Department of Parks, Recreation and Waterfront
Waterfront Capital Improvements Program Division

March 7, 2024

**CITY OF BERKELEY
BERKELEY MARINA DOCKS D & E REPLACEMENT
SPEC. NO. 24-11633-C**

ADDENDUM NO. 2

TRELLIS DETAIL
SCALE: 1/2" = 1'-0"

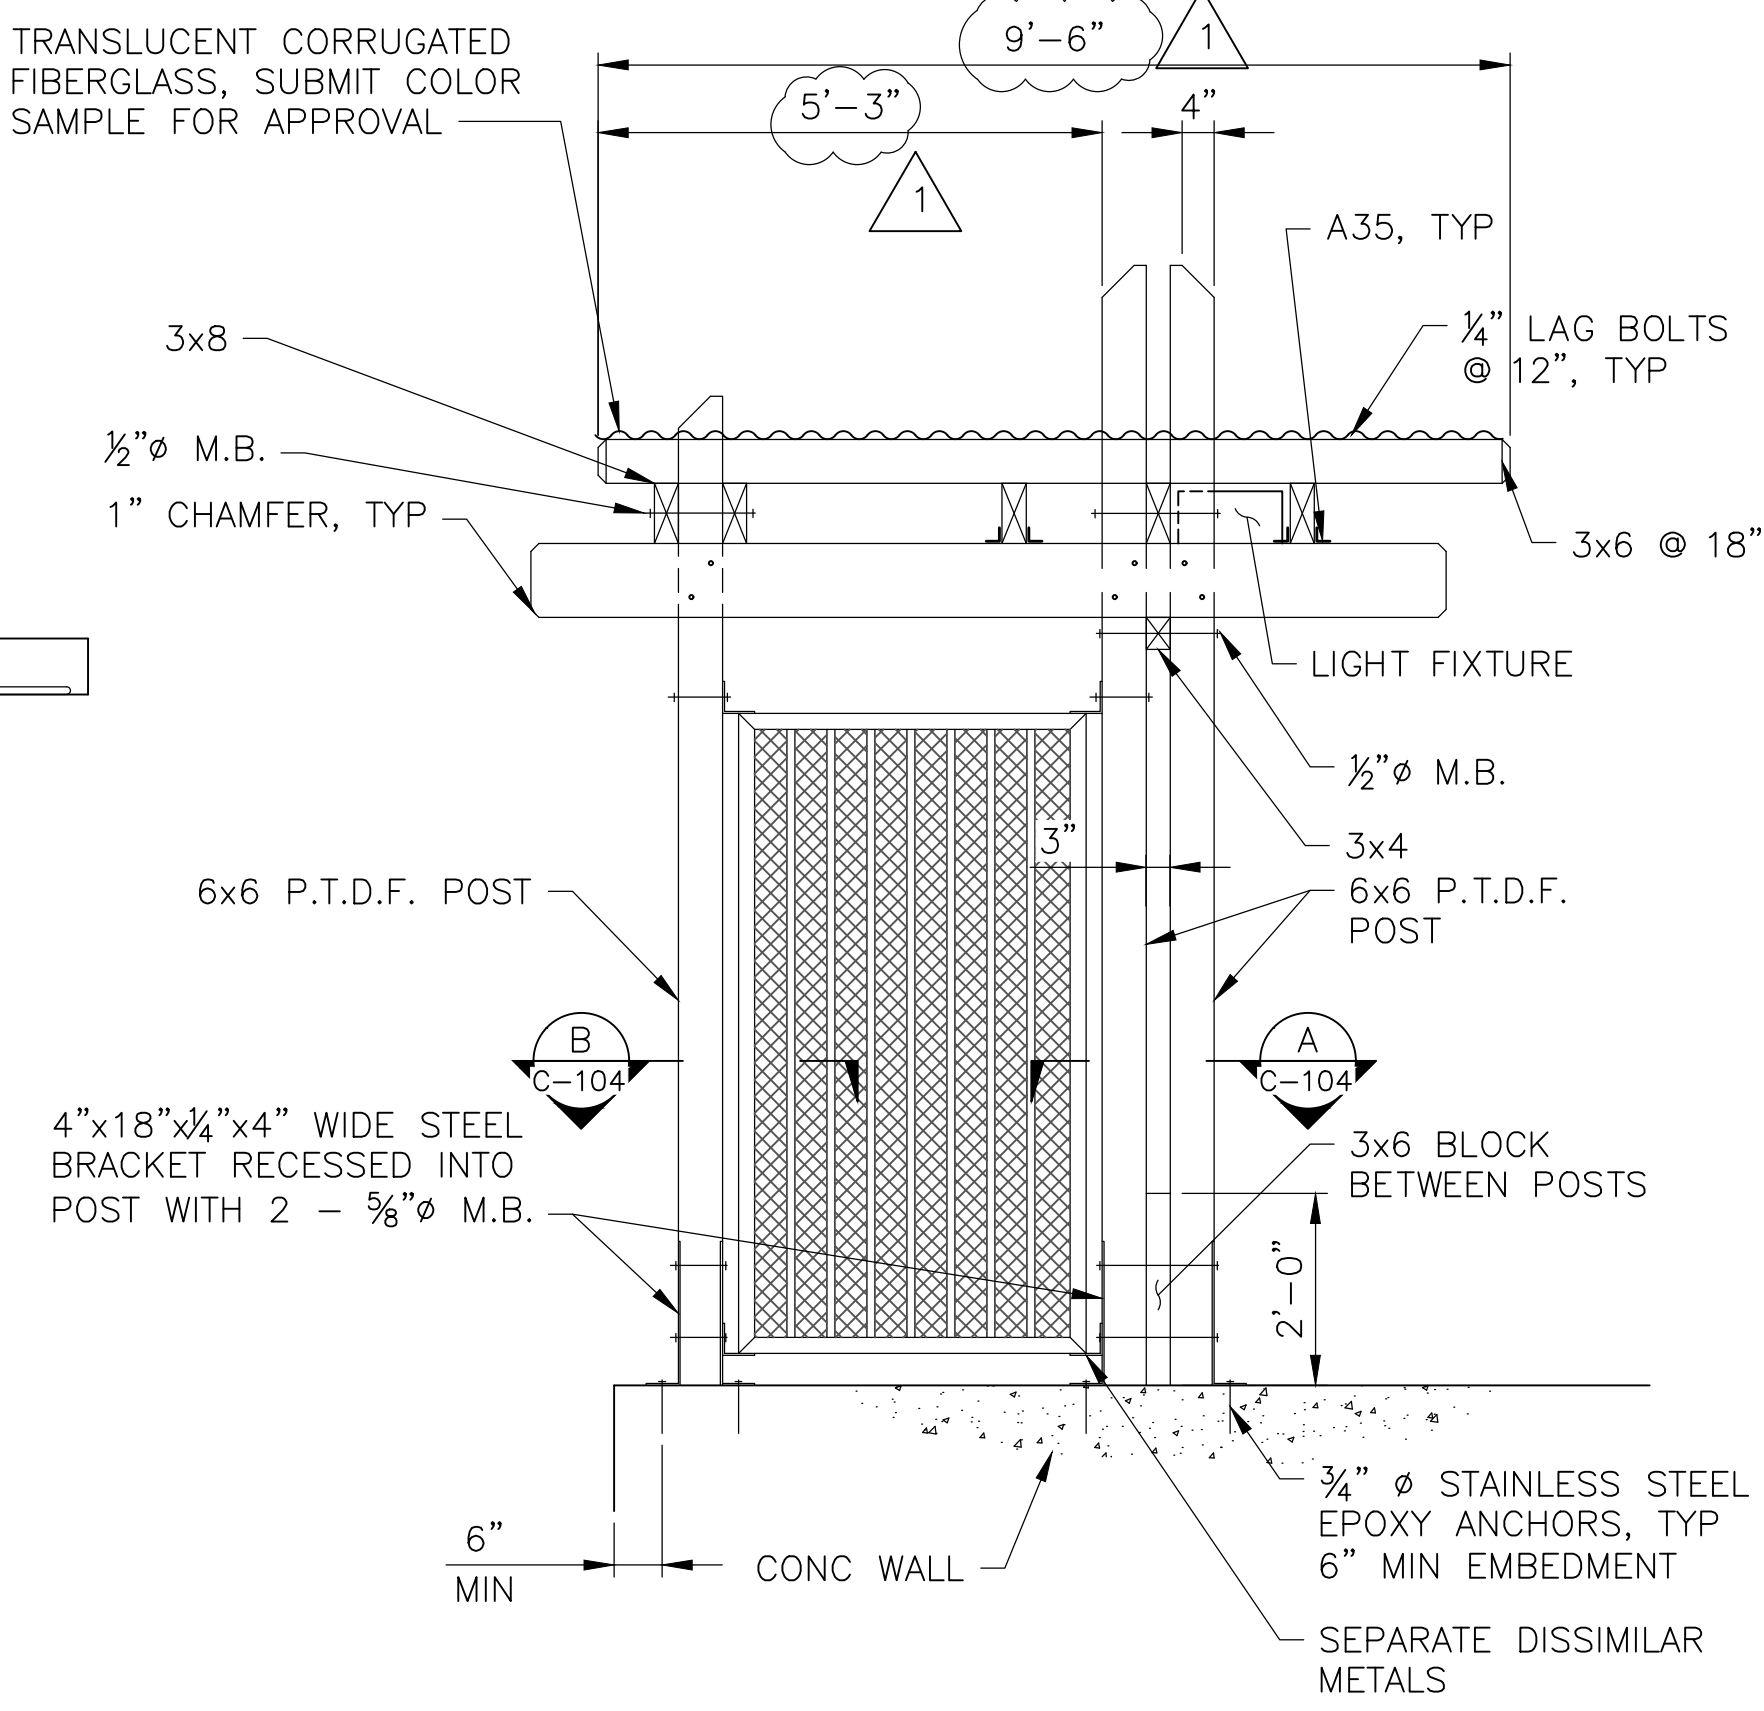
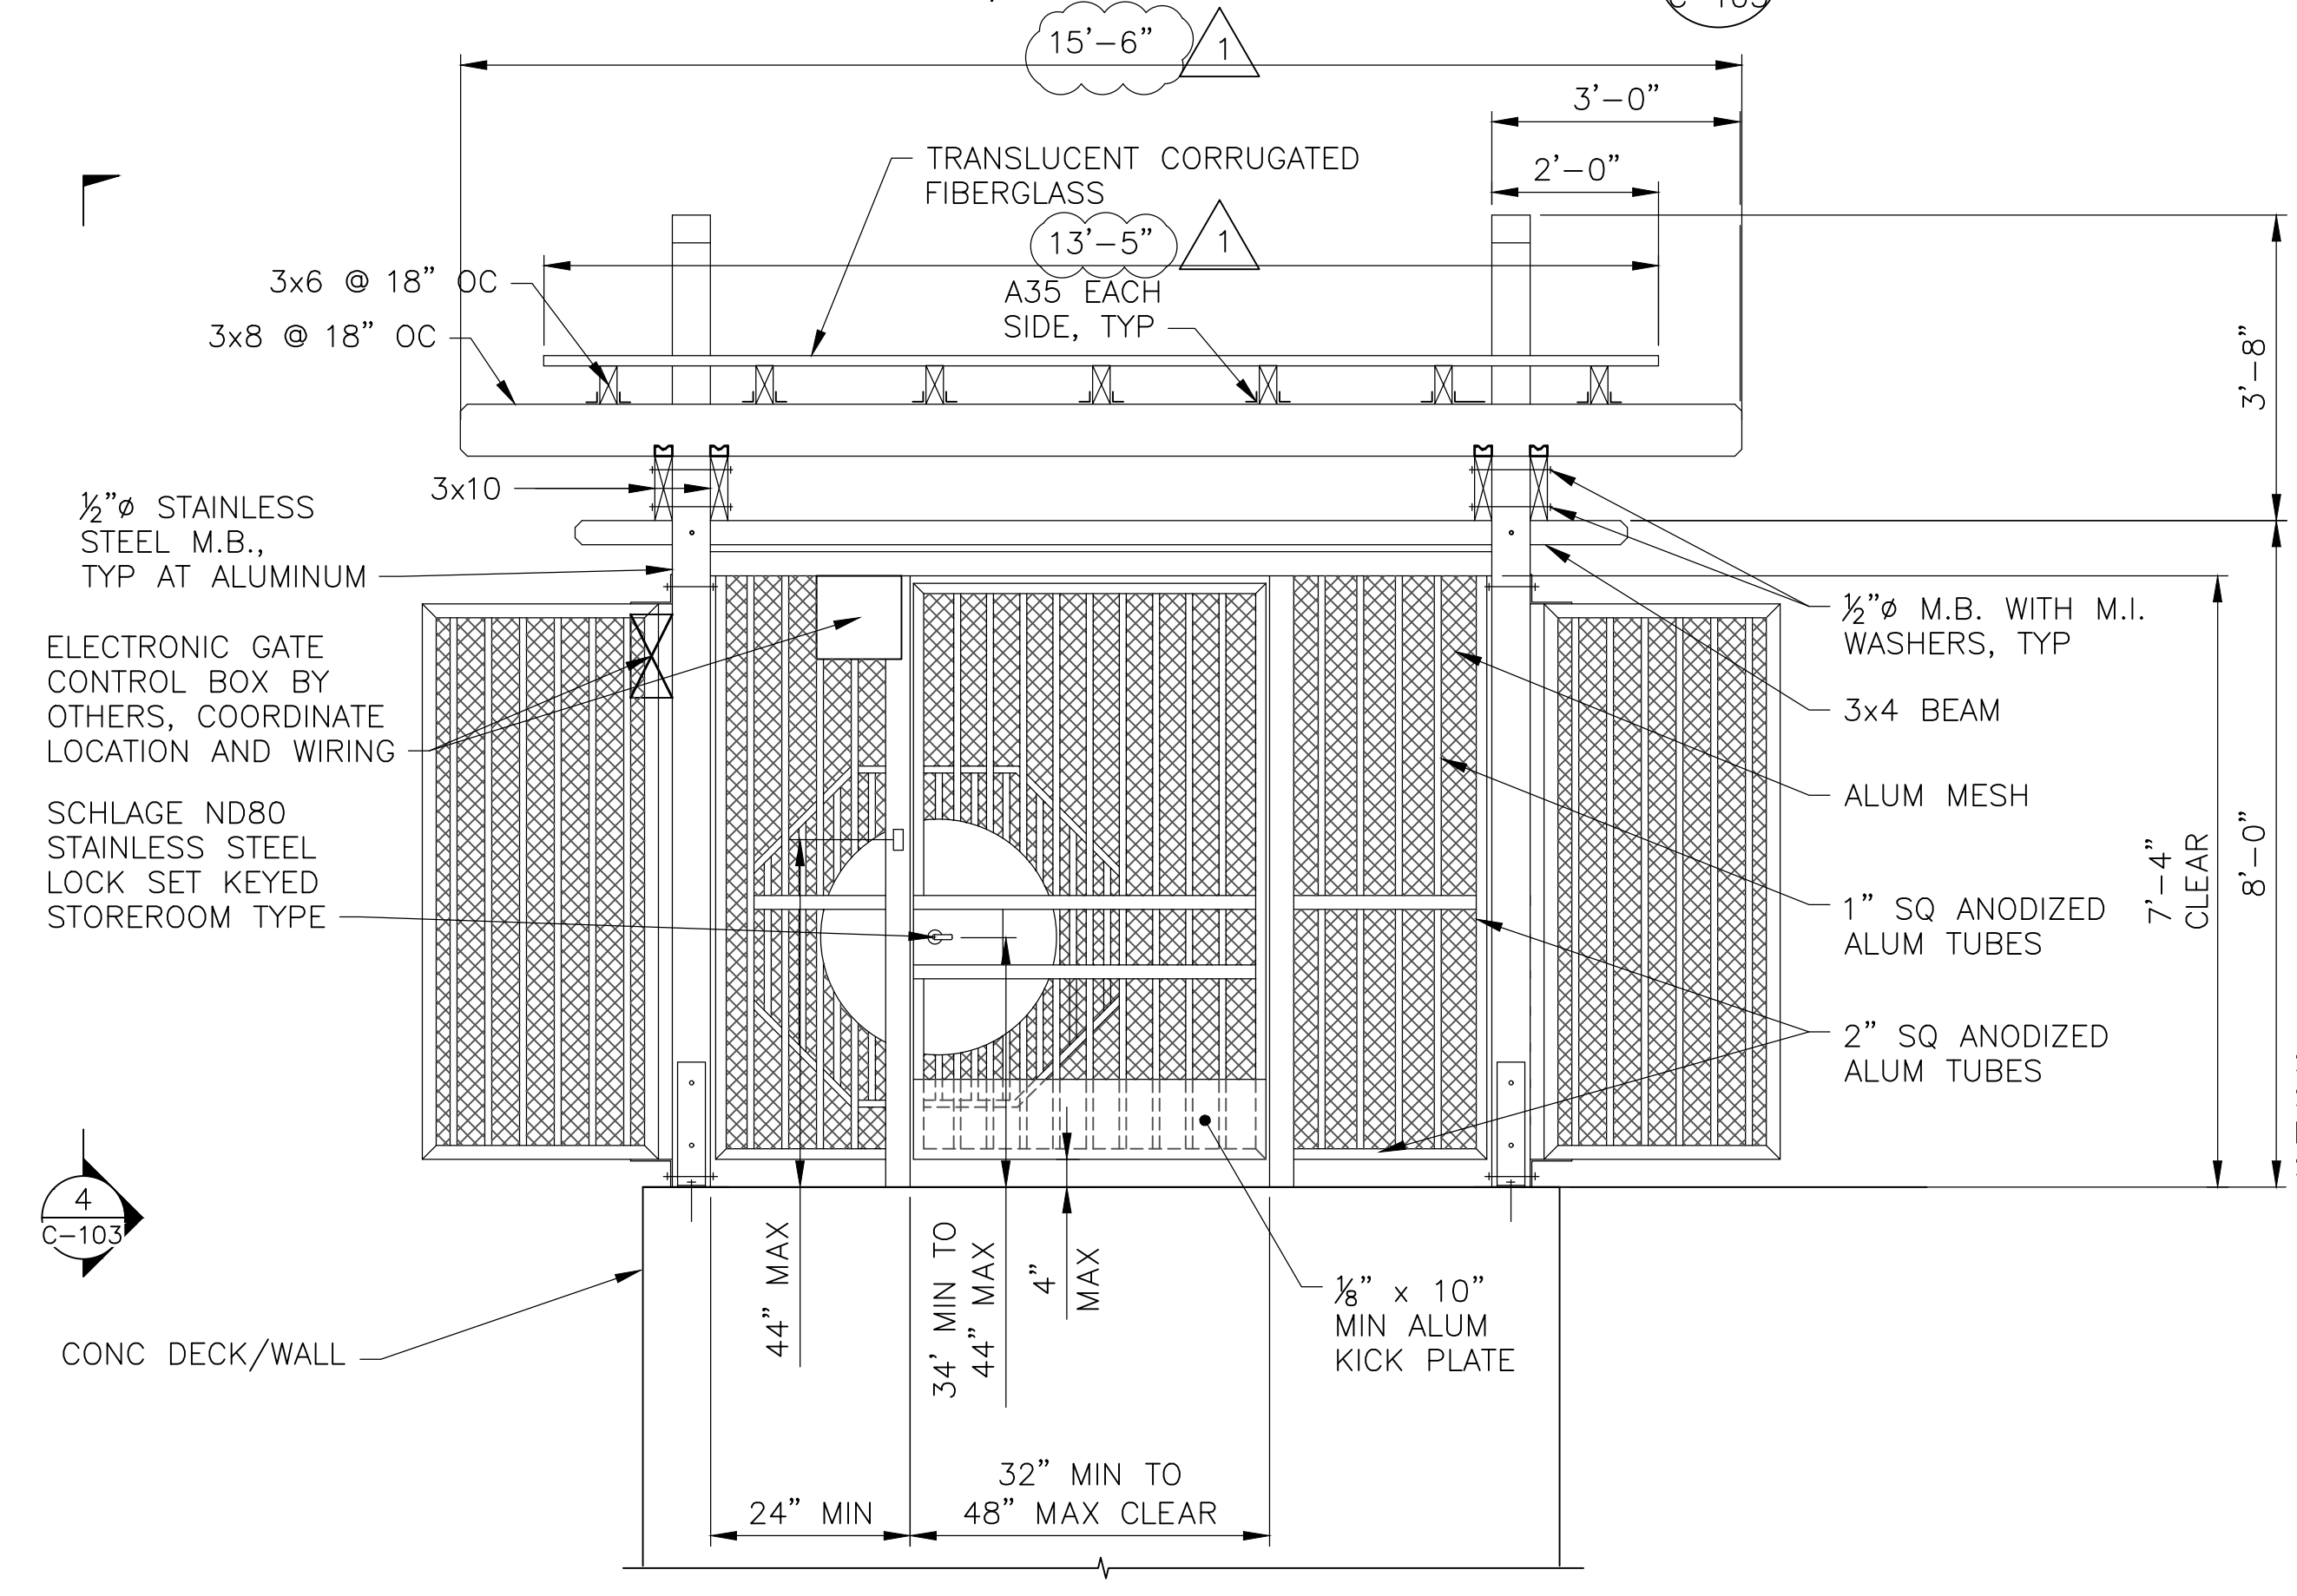
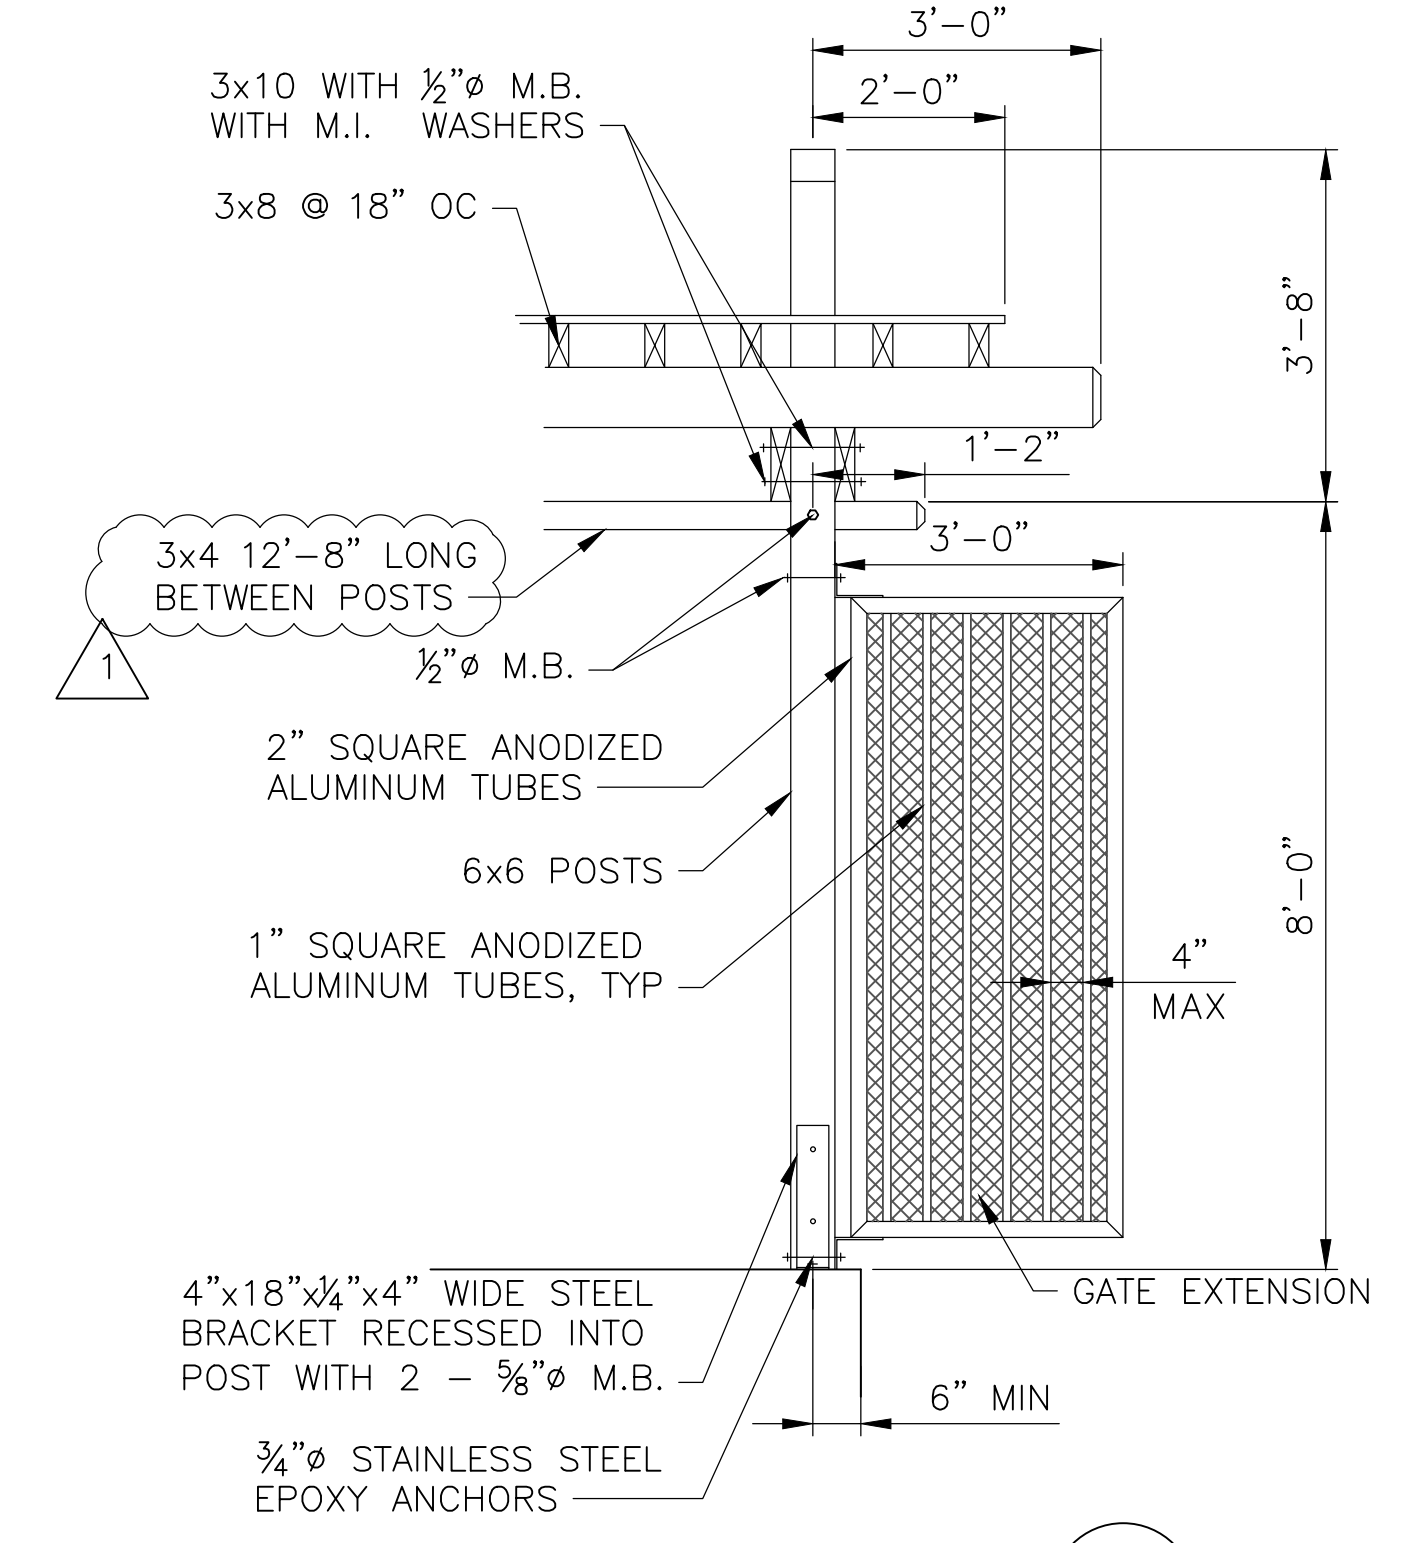
- Revisions to gate and trellis details
8. **Specifications:** Document 00 01 10 Table of Contents
REPLACE with attached revised Document 00 0110 Table of Contents

13. Detail 2/C-103 shows the 3x8 beams at 18" o.c. but detail 3/C-103 (which is a scaled detail) clearly shows a different spacing scenario for those components. If it is to be 18" o.c., what extents does that measurement start/stop so that we can get an accurate take-off of those components?

14. Detail 2/C-103 shows a 3x4 beam that doesn't seem to be indicated on 3/C-103. Is it possible this 3x4 occurs only once, sandwiched between the taller 6x6 posts (as their seems to be a fastener call-out in that location shown on 3/C-103)?

Response: New Dock D and E are to be similar to Existing Dock B and C, see picture below and revised Sheet C-103 attached.

Response: Confirmed, the 3x4 beam only happens once between post. See image of Dock B and C, and modification to Sheet C-103 attached.
